| Illinois Tollway Standard Drawing Revisions |

| Section E | Maintenance of Traffic |                                                                                                                                                                                                                                                                     |                       |
|           | Standard               | Modification Summary                                                                                                                                                                                                                                                | Effective: 03-01-2025 |

EMERGENCY PULL-OUT AREA

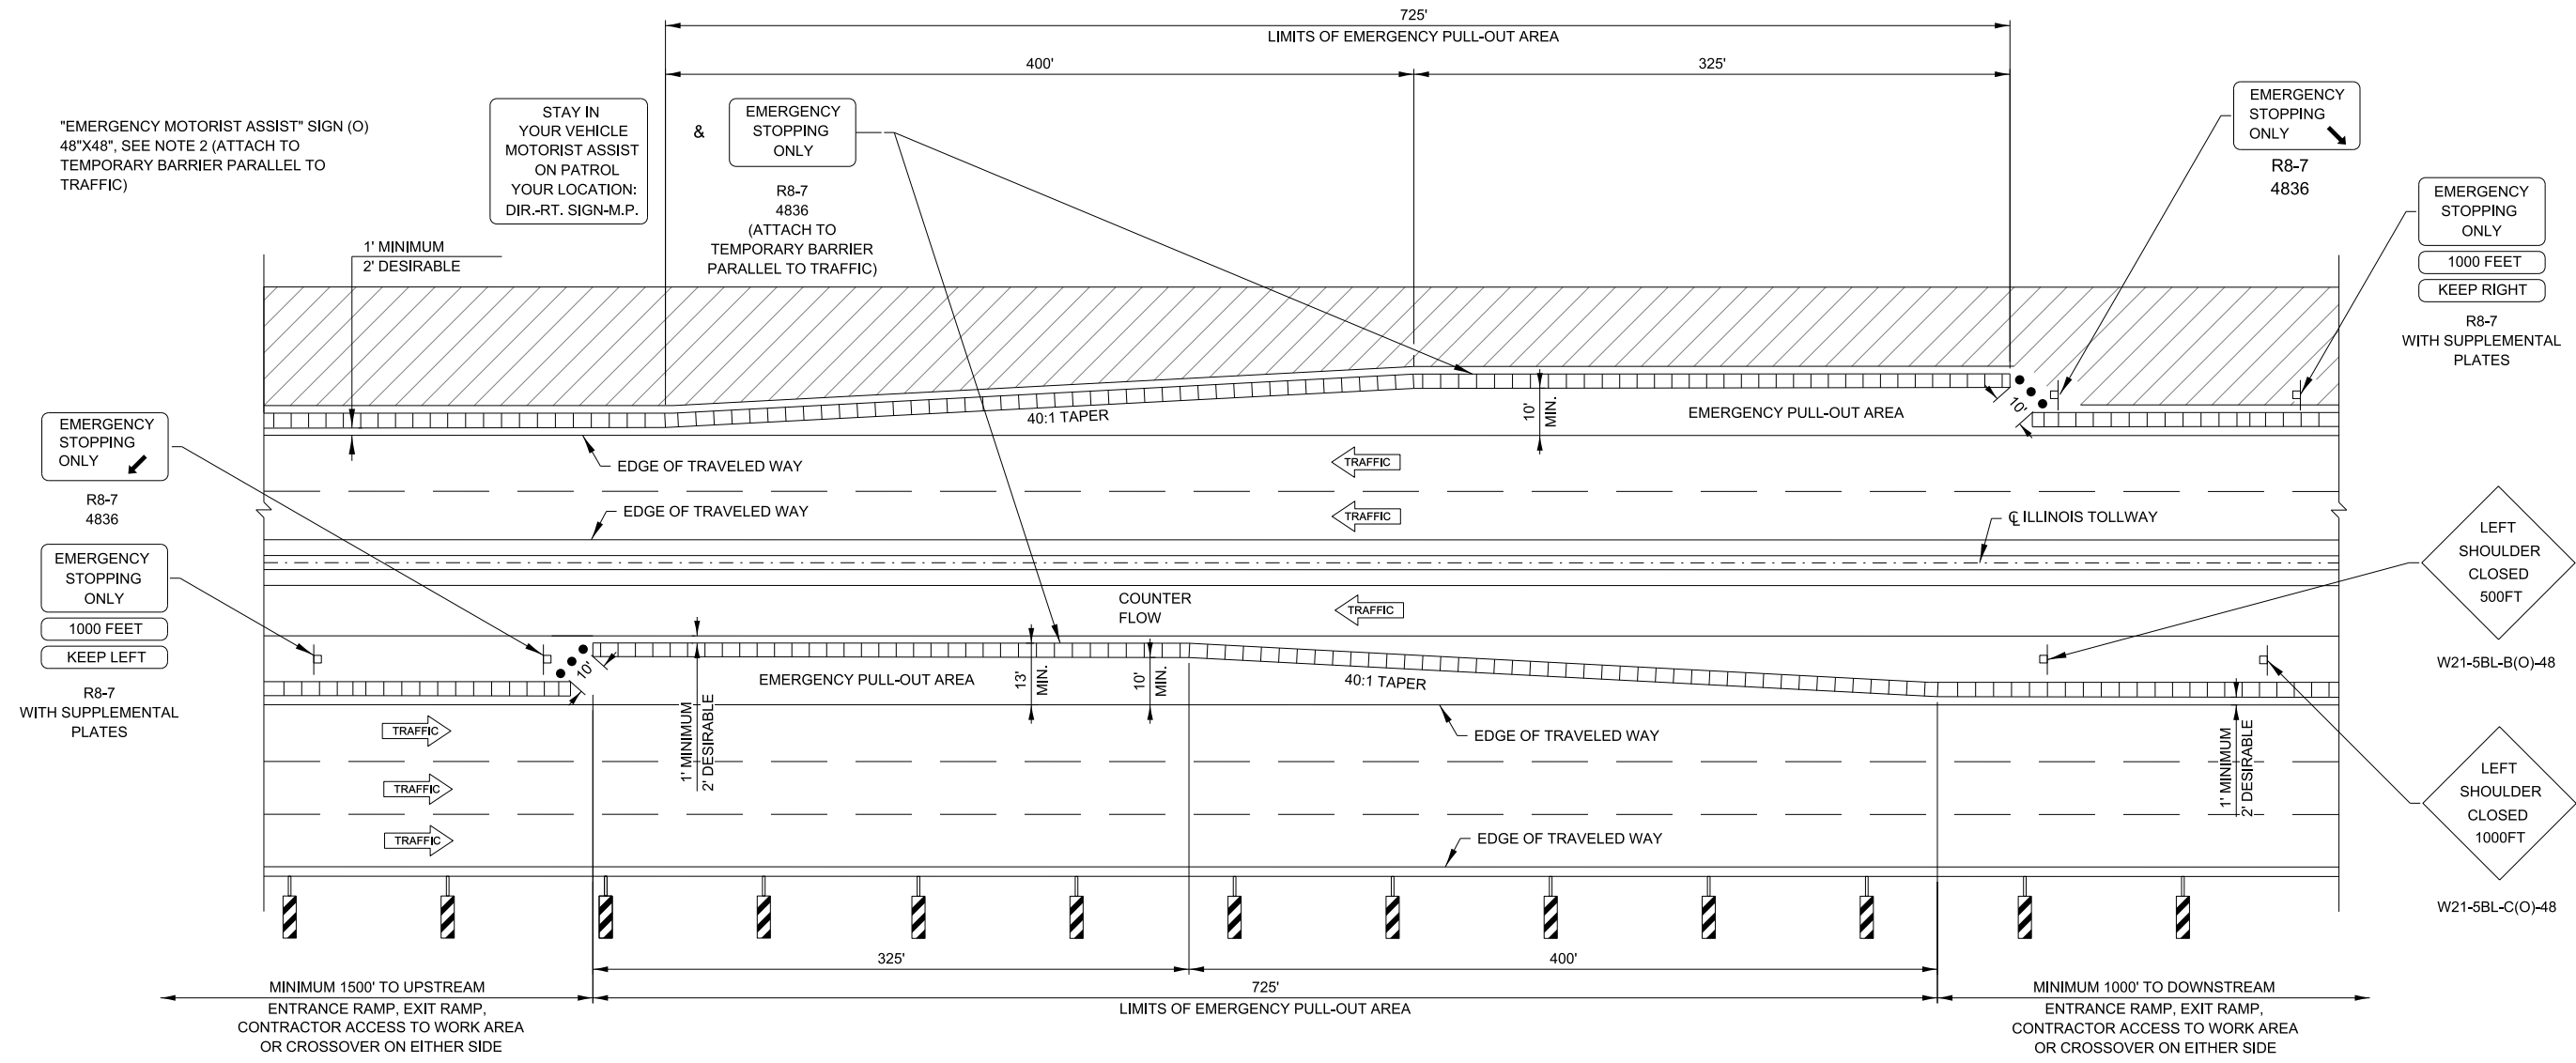
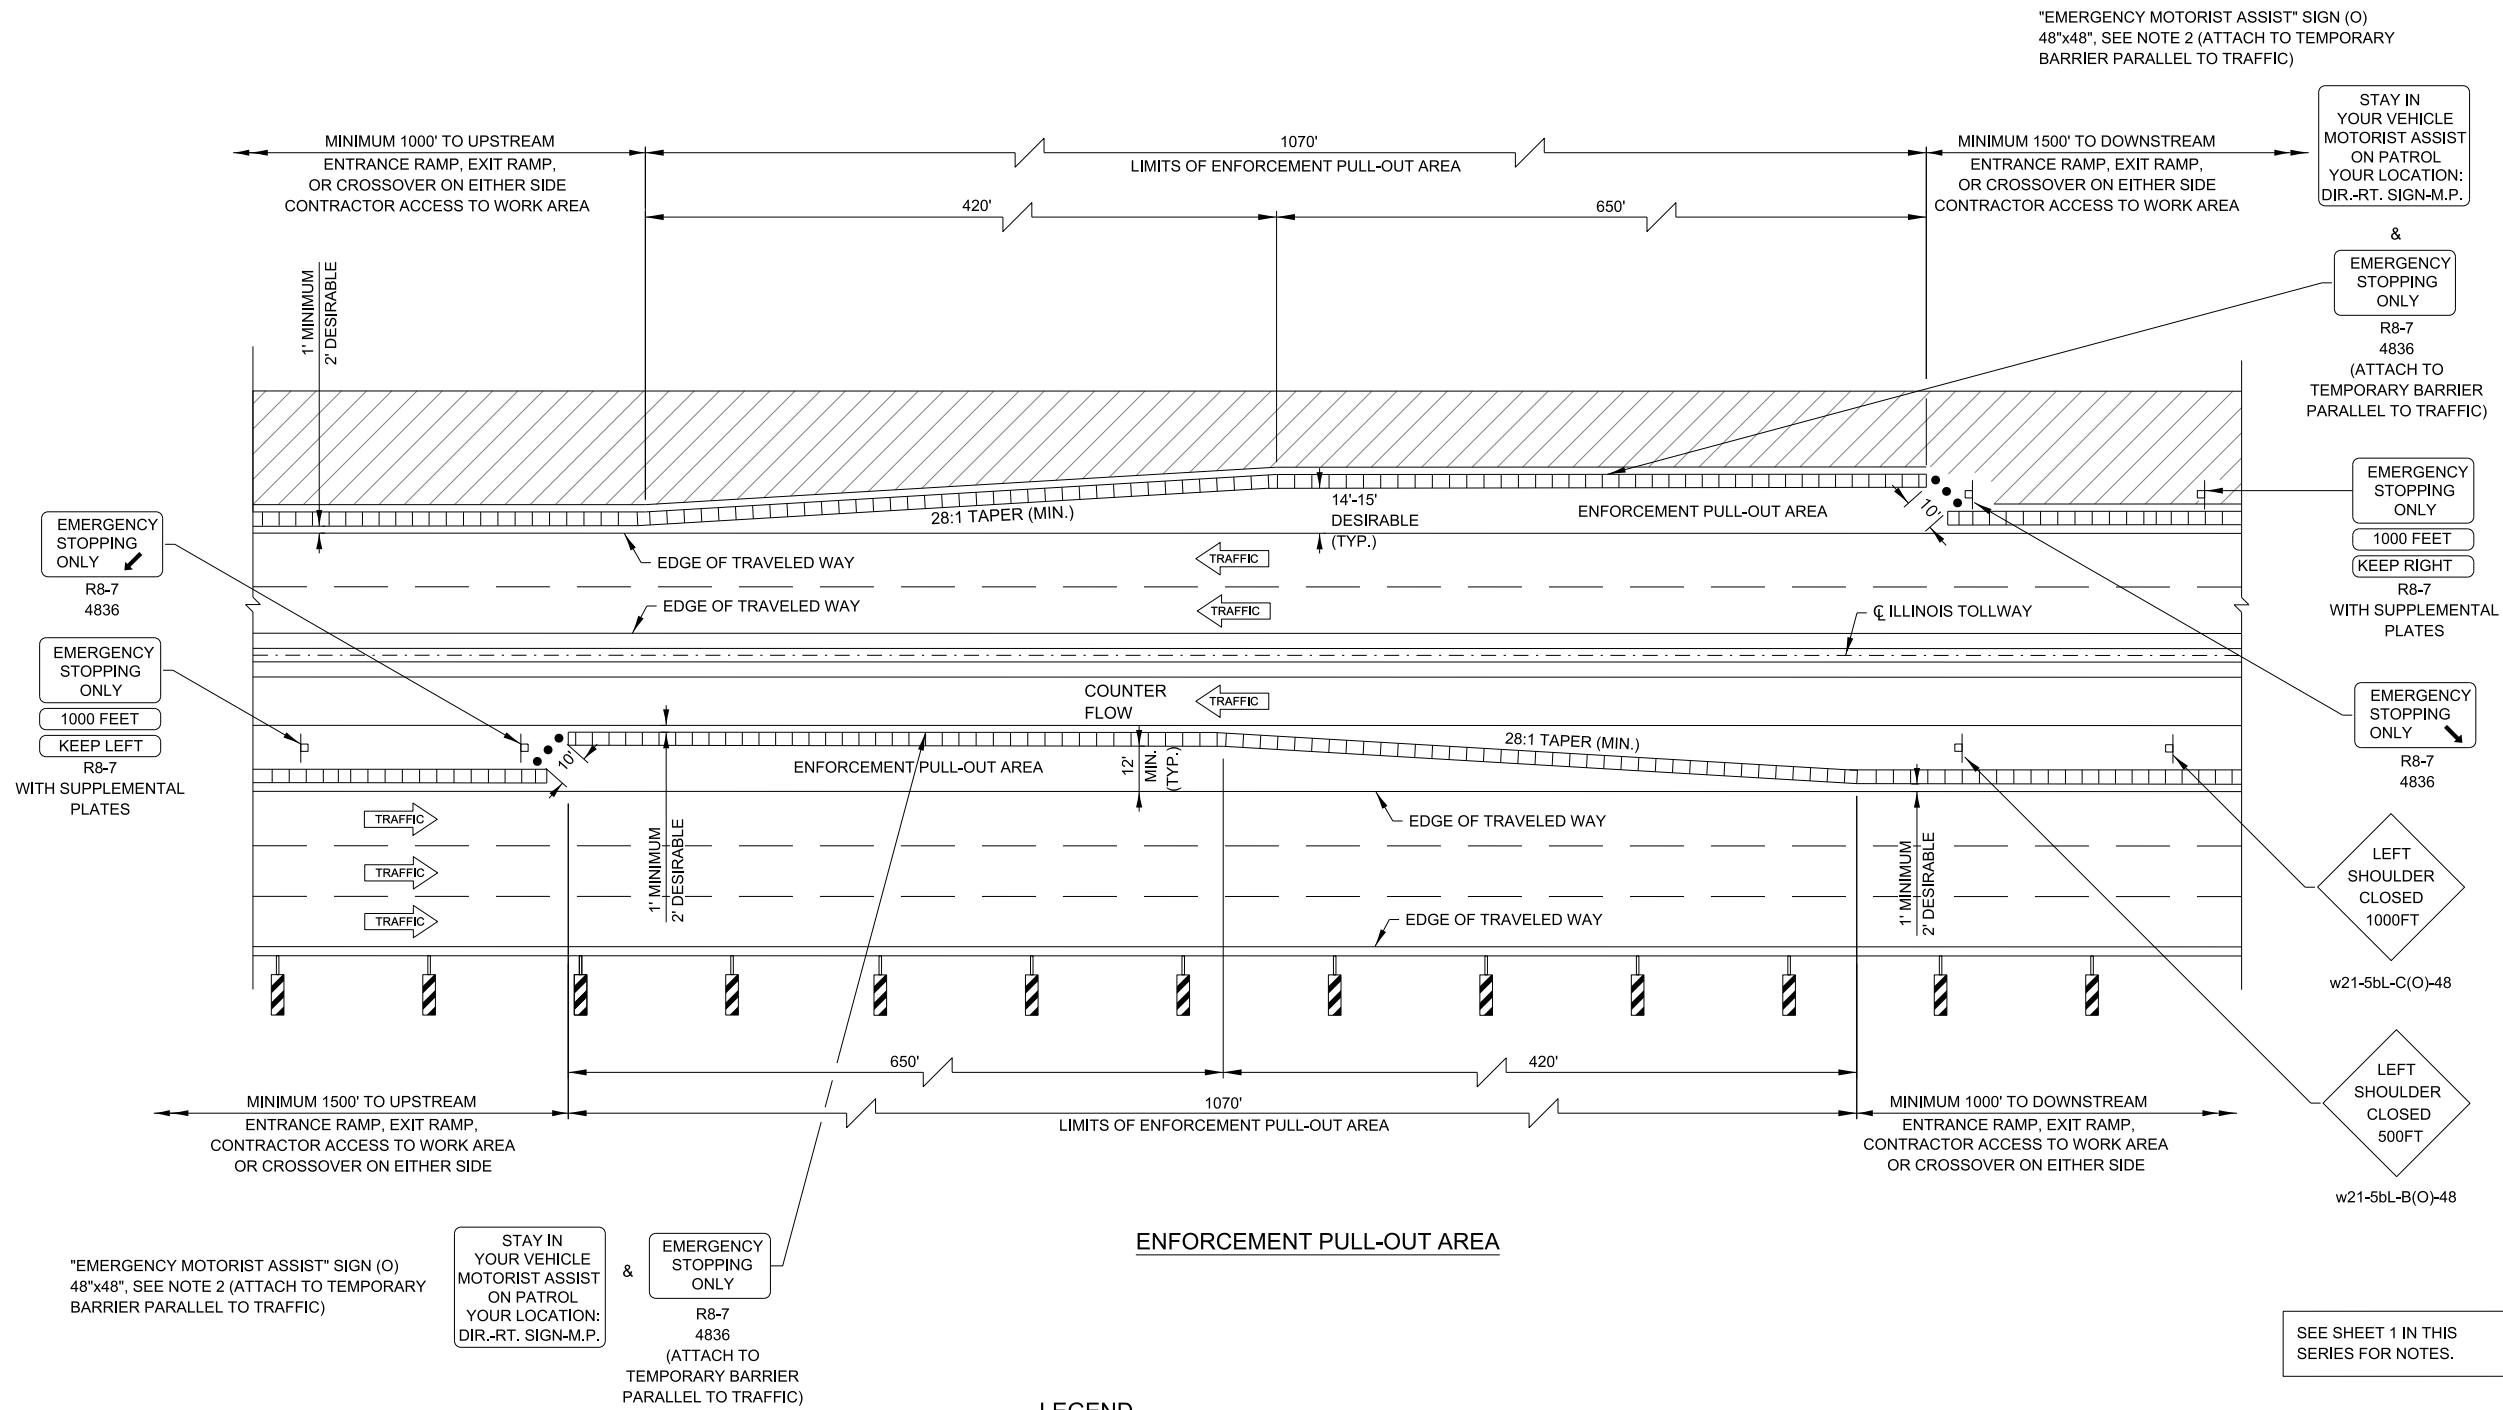
| Section E | Maintenance of Traffic |                                                                                                                                                                                                                                                                     |                       |
|-----------|------------------------|---------------------------------------------------------------------------------------------------------------------------------------------------------------------------------------------------------------------------------------------------------------------|-----------------------|
|           | Sheets 1 & 2           | Revised work area hatching behind TCB                                                                                                                                                                                                                               |                       |

| REVISIONS  |                                     |
|------------|-------------------------------------|
| 03-01-2025 | REDUCED WORK AREA BEHIND TCB        |
